SERVICE TECHNICAL INFORMATION

ONE POINT REPAIR

UTSUNOMIYA, DECEMBER 30, 1997
REF. NO.: SI-97-061
CUSTOMER RELATIONS & SERVICE DIV.

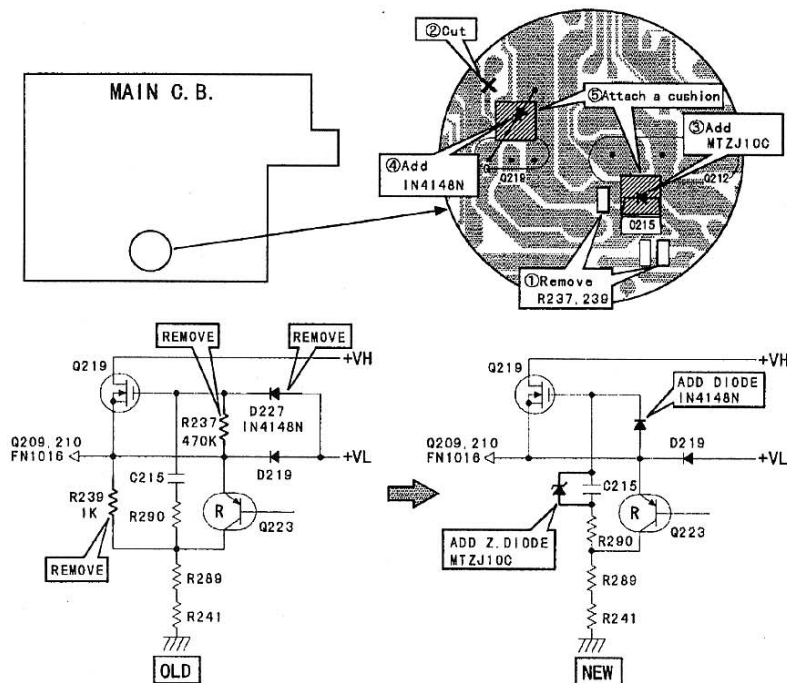
- MODELS : NSX-F9, F12, F15, NK950, S94, S95, R900, RK900, RK850, R800
SUBJECT : No power
DESCRIPTION : When the FET of the power amplifier fails, there is a case that the transistor on the power stage also fails and a phenomenon of "No power" occurs.
REMEDIES : Exchange the FET and transistor and take the following countermeasures at the same time.
- ① Remove R237 (470 k Ω) and R239 (1 k Ω) on the MAIN C.B.
 - ② Cut the pattern of D227 on the cathode side.
 - ③ Solder the Zener diode MTZJ10C at both ends of C215.
 - ④ Add the diode IN4148N between the Q219 gate and D219 cathode.
 - ⑤ Attach a cushion under the added Zener diode and diode.

- * The Darlingtion transistors on the power amplifier unit are complementarily connected. Even if only one transistor is faulty, when exchanging it, be sure to exchange a pair of transistors.

Ref.	Part Name	Part No.	Remarks
	ZENER, DIODE MTZJ10C	87-A40-345-080	1 piece
	DIODE, IN4148N	87-A40-291-080	1 piece
	CUSH-S, PWB	80-VX1-218-010	2 piece
